**PCN# 20240613004.1**

**Qualification of FFAB using qualified Process Technology, Die Revision, and additional Assembly BOM options for select devices  
Change Notification / Sample Request**

**Date:** June 13, 2024

Sample product shipping label (not actual product label):

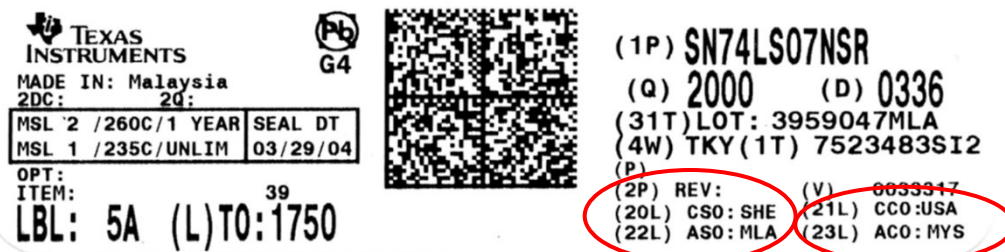
<input type="checkbox"/> No Change		<input type="checkbox"/> No Change		<input type="checkbox"/> No Change	
<b>Changes to product identification resulting from this PCN:</b>					
<b>Fab Site Information:</b>					
Chip Site	Chip Site Origin Code (20L)	Chip Site Country Code (21L)	Chip Site City		
SH-BIP-1	SHE	USA	Sherman		
<b>FR-BIP-1</b>	<b>TID</b>	<b>DEU</b>	<b>Freising</b>

**Die Rev:**  
**Current**

**New**

Die Rev [2P]	Die Rev [2P]
D	C
